Subject: Staff Concurrence for Activation of Freezeway

Subject: Completion of Soils Remedial Activities Review

LISTING OF ENCLOSURES

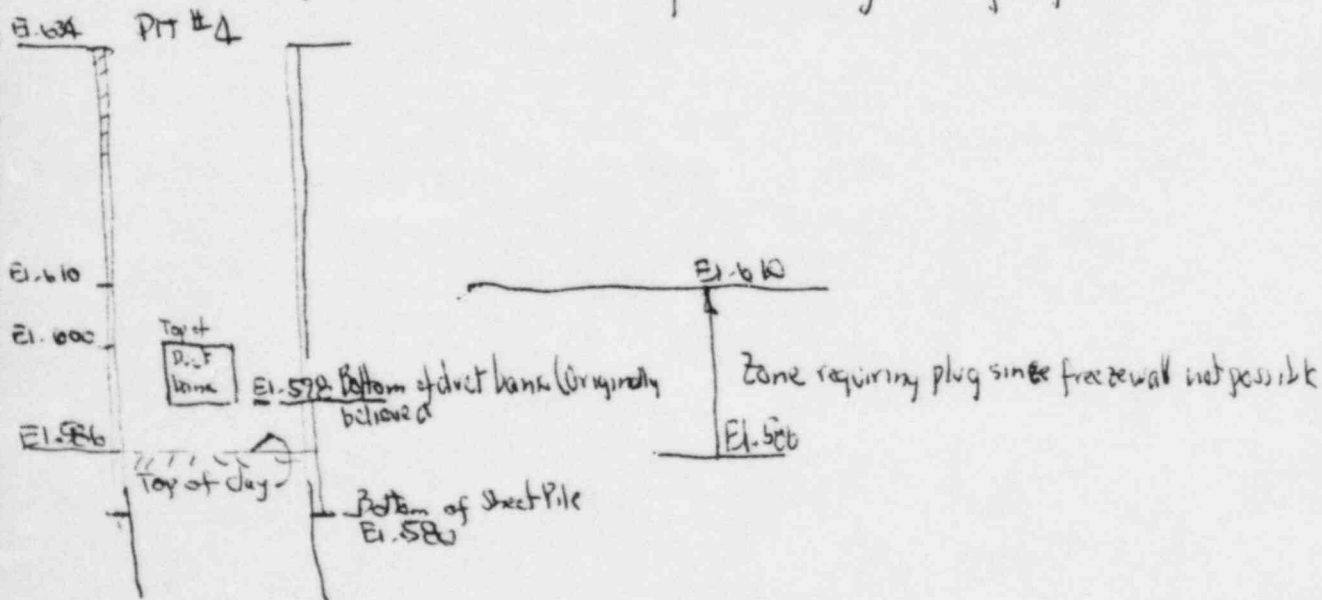
- \* Cover the May 20, 1982 meeting SEPARATELY from the May 21, 1982 EXIT Interview - This could free me as a witness
- \* Refer to pgs 8 & 9 of Mr. Mooney's testimony. Ask Mr. Mooney where in the May 25, 1982 letter from NRC does he interpret NRC gave explicit approval for the deep duct bank excavation. The references given in Encl # 4, Par. I. c. are the basis for the Staff's approval to go ahead with the Freezeway, but these references are dated up to Feb '82. As noted in Mr. Mooney statement to C.I (Pg. 13) he indicates that the change in methodology was being brought to NRC attention on May 20, 1982 for the first time and NRC was surprised

- What is present condition @ monitoring pit no. 4 - ~~If not backfilled~~ - what is preventing seepage?

- Why the May 25, 1982 letter DID NOT APPROVE the deep Q duct bank
- <sup>contents of</sup> NRC Letter dated May 25, 1982 was prepared prior to May 20, 1982 meeting
  - Jim Mooney in his interview with C. Weil recalls NRC surprise @ CPC changed methodology for surcharging pits & concern for differential settlement (Pit No. 4)
  - (Pg. 21 of Investigation Report) Mooney indicates drawing of pit no. 4 with concrete backfill was shown to J. Kane on May 20, 1982 but advises these drawings have never been formally submitted to NRC Without the drawing I would not be able to make intelligent evaluation of problem nor be able to document my findings
  - On pg. 8<sup>th</sup> of Testimony by Mooney & Wheeler concerning the Alleged Violations of the April 30 ASLB Order - Mr. Mooney indicates the May 25, 1982 letter states that

see JCR note to file dated 1/6/83  
Was backfilled w/ clay in 3' to 4' layers to 95% modified
